Answers to Review #1

Answers to Review #2

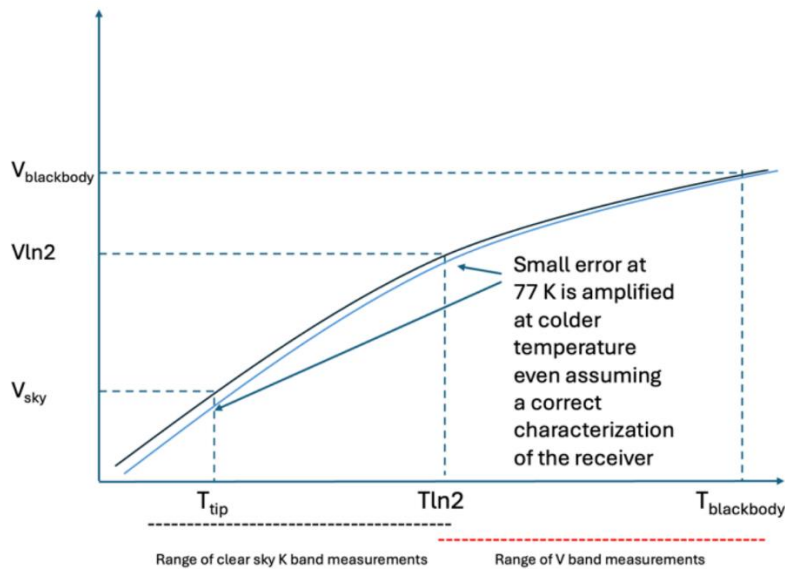
My main comment relates to some of the assumptions on the LN2 calibration for channels between 20 and 30 GHz. Specifically, the assumption that if the agreement with the estimated cold target temperature (77 K) is in within a certain range, that is also true when the instrument is looking at the sky.

LN2 calibrates the radiometer in a range of temperatures that is mostly outside the range of what is observed. The “cold” target (~77 K) is actually very warm as the measured brightness temperatures can be as low as 10-15 K (or even lower in high latitudes). Therefore, an accurate calibration is achieved between ~77 K and ~290 K (warm target) forcing an extrapolation to the lower temperature that is prone to larger uncertainties.

- That is correct. We added this at lines 475f.
